UNION ELECTRIC COMPANY

ULNRC-938

DOCKET NUMBER 50-483
CALLAWAY PLANT, UNIT 1
REVISION TO TECHNICAL SPECIFICATION 4.6.1.2 AND
3/4.6.1.2 BASES

ATTACHMENT ONE

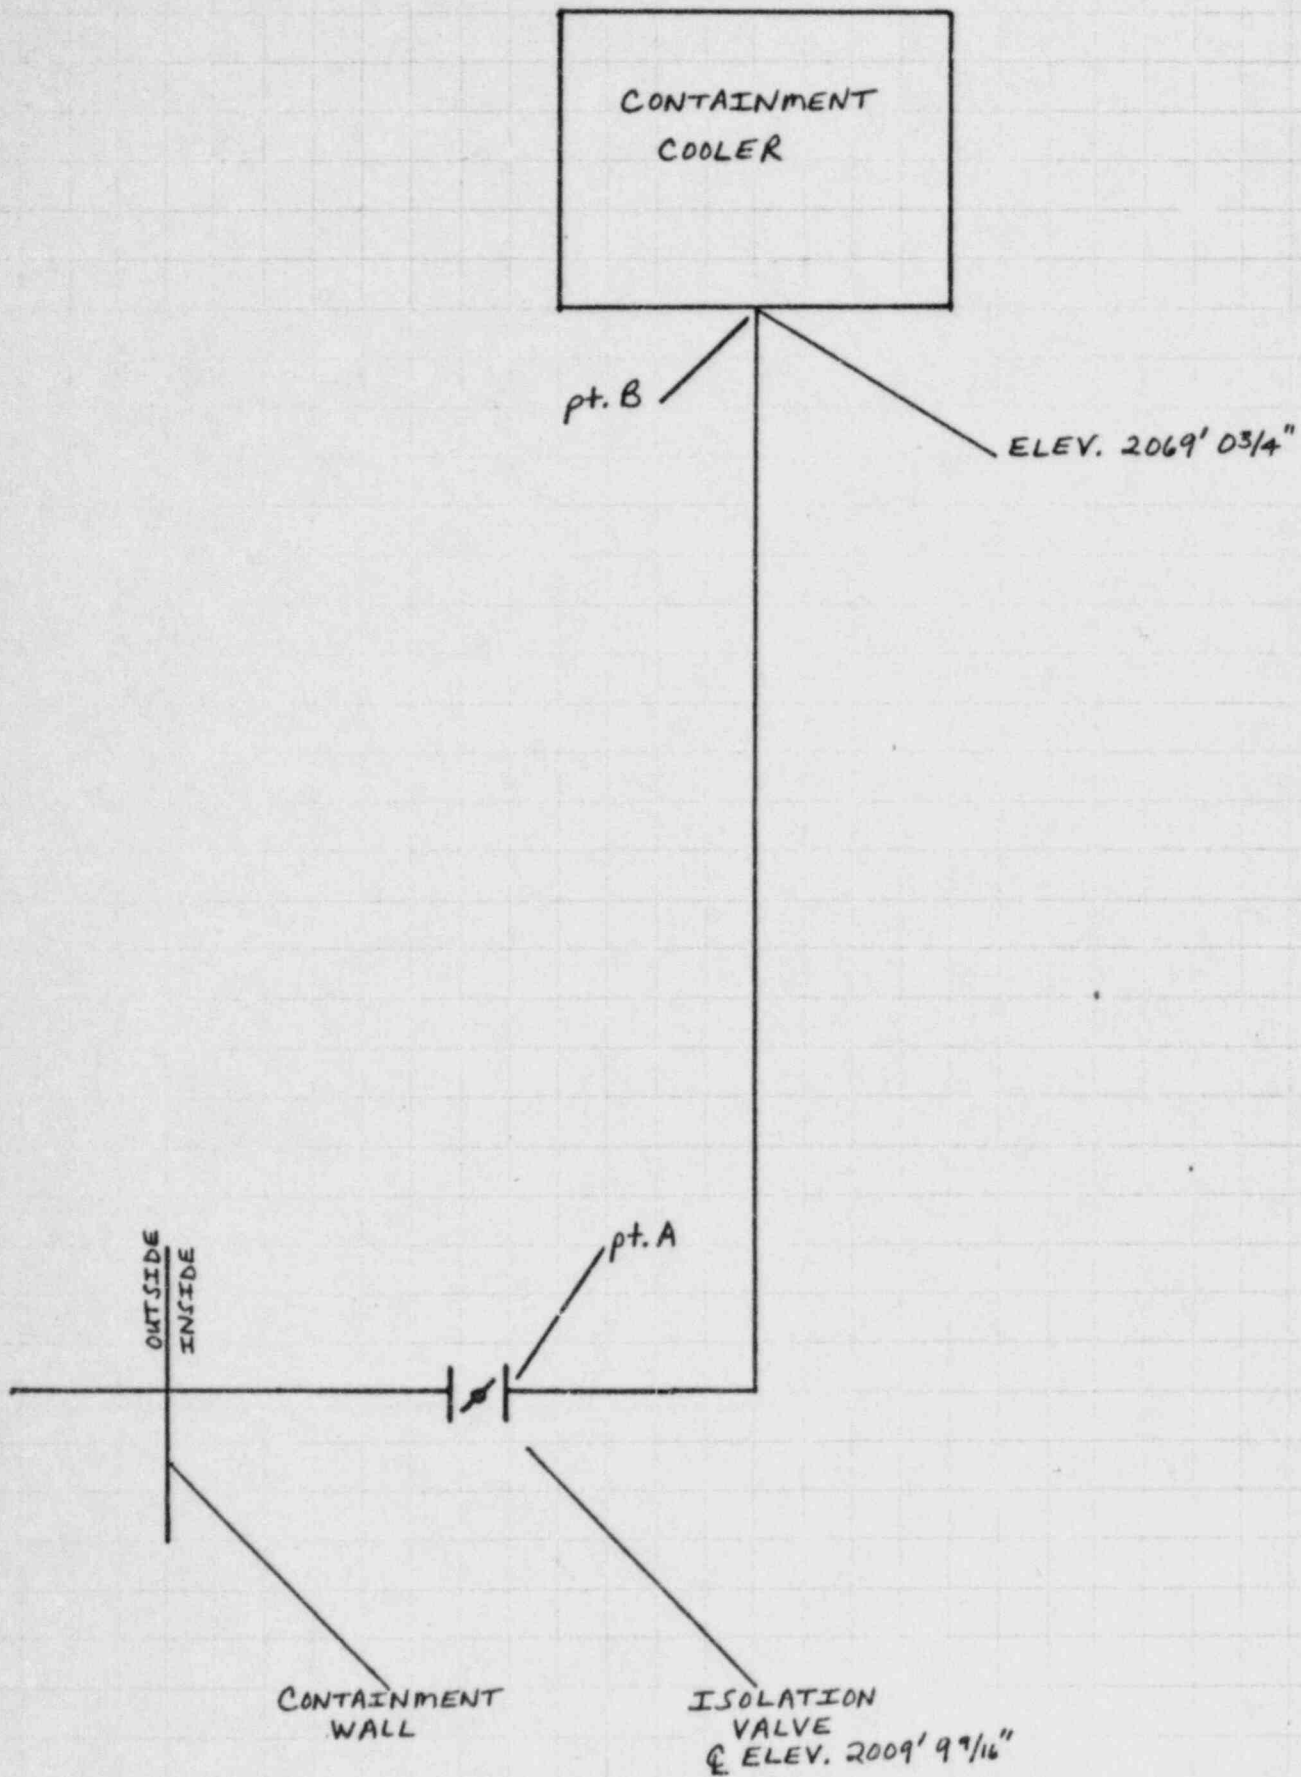
With respect to the system not meeting the precise requirements of a closed system inside containment, the effects of a passive failure are addressed as follows.

Passive failures in ESF systems are postulated during the long term post-accident phase in accordance with FSAR Section 3.1.1 and in accordance with NRC guidelines. When passive failures are postulated in the long term (24 hours), no single active failures need be considered; therefore, the ESW pumps and all valves would be operable. As noted in FSAR Section 3.1.1.4, passive component failures when applied to fluid systems mean abnormal leakage from a single sprung flange, a single pump seal failure, or a single valve stem packing failure, and not from a piping failure. This definition of a passive failure is in agreement with the NRC staff position stated in Issue #7 of NUREG 0138.
